Product Change Notice (PCN)

Subject: Assembly factory addition and assembly materials change for RL78/L1A, L1C LQFP package products

Difference of specification 1 (RL78 family LQFP products) 14x14mm 0.5mm pitch 100pin

Difference of specification 2 (RL78 family LQFP products) 14x14mm 0.5mm pitch 100pin

14mm x 14mm 0.5mm pitch 100pin LFQFP Package outline (RSB)

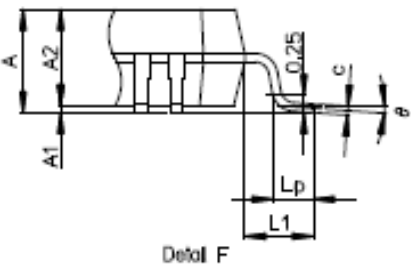
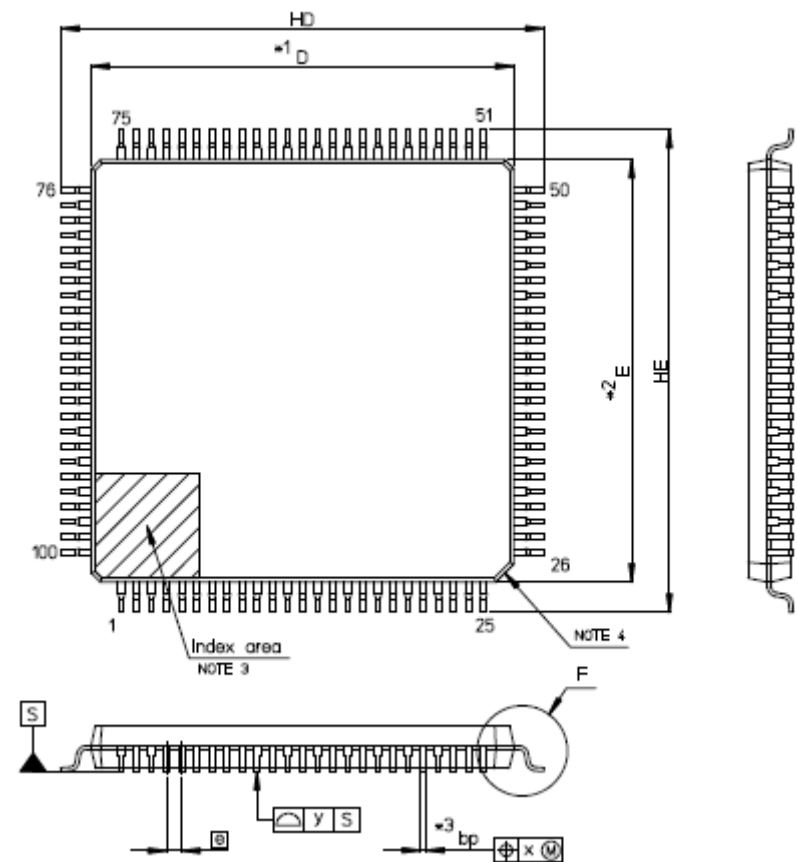
Dimension comparison: 14mm x 14mm 0.5mm pitch 100pin LFQFP

Greatek package symbols complied JEDEC standard.

Package structure image

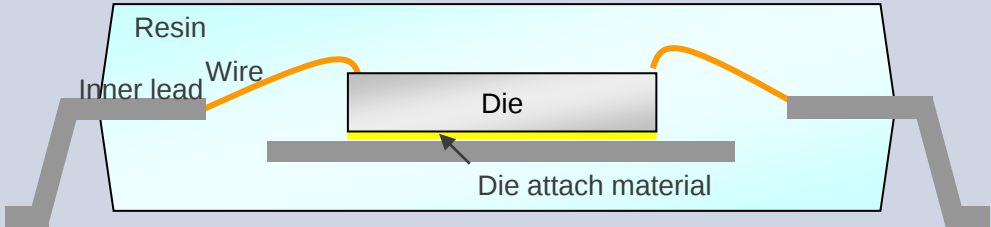
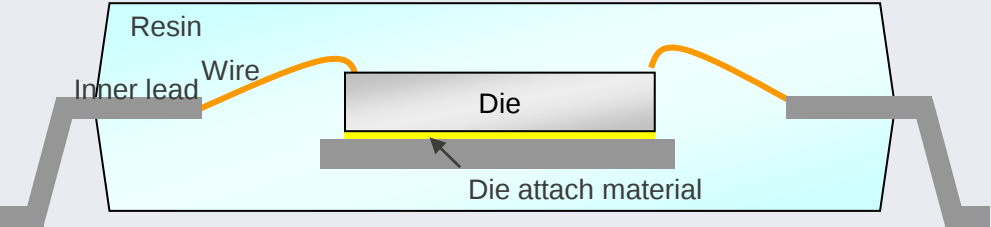
Assembly Line	PKG cross section	Die pad shape
Additional factory		 Greatek
Existing factory		 RSB

✂ There is no impact on the reliability by die pad shape

14×14mm 0.5mm pitch 100pin LFQFP lead frame

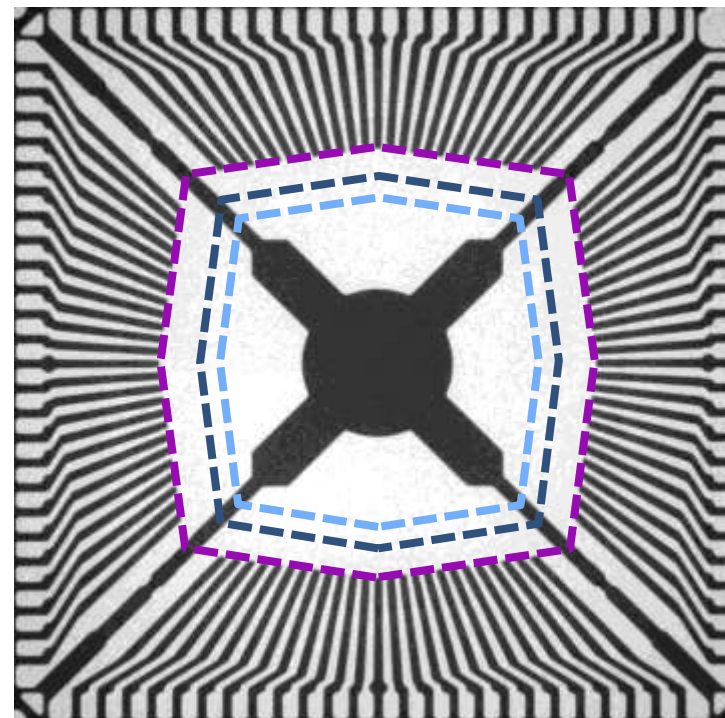
Consolidate into certified and proven lead frames.

After consolidated “Frame C”
